Groundwater & Wastewater Services
Septic Project File & Data Review Worksheet

GWS File #: 76093 WASPS App #: 3210

SOIL/SITE EVALUATION
for ON-SITE WASTEWATER SYSTEM

GWS Septic System Design Review

Sketch of Soil Evaluation Locations

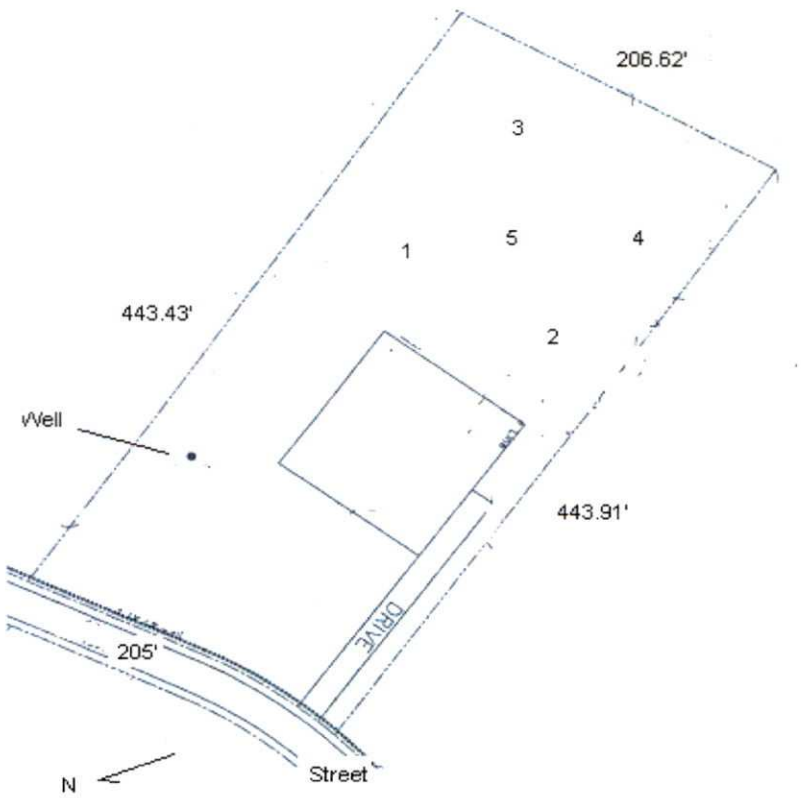
100% repair, recommend spot checks with auger borings on proposed drainlines around area of pit 5

File # 7609B
App ID 3218

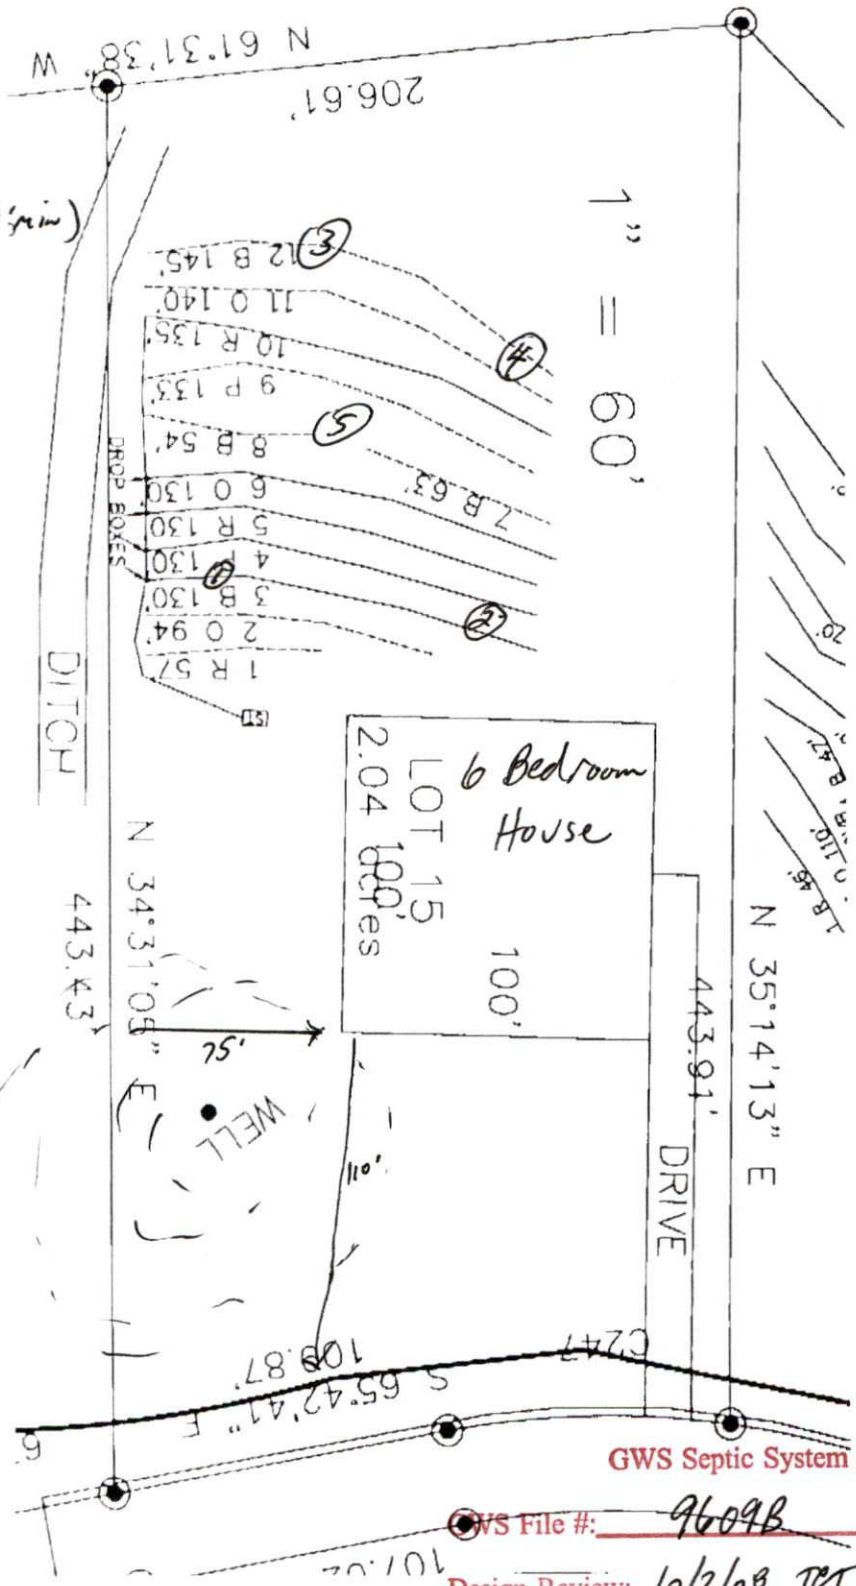
COMMENTS 6 Bedroom House w/ Basement

- Scale 1" = 60'
- LTAR .275

Keep the septic system > 100' (50' min) from any wells
